भारत सरकार — रेल मंत्रालय
अनुसंधान अभिकल्प और मानक संगठन
लखनऊ — 226011
Government of India - Ministry of Railways
Research, Designs & Standards
Organization, LUCKNOW - 226011

MODIFICATION SHEET NO. RDSO/2013/EL/MS/0428, (Rev.0), Dated 10.12.13

Modification Sheet for relocation of earth fault relays for harmonic filter and hotel load along with its resistors in three phase electric locomotives.

Fig. 3

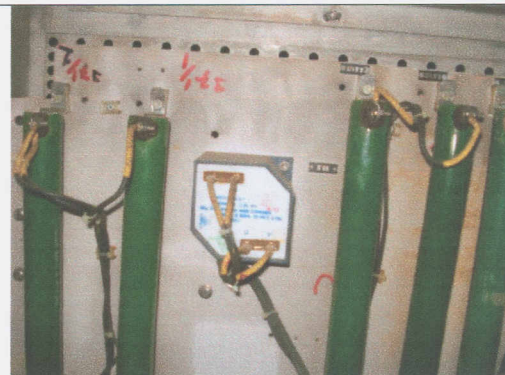
Resistance and Earth fault relay can be checked / changed from FB cubicle inspection window.
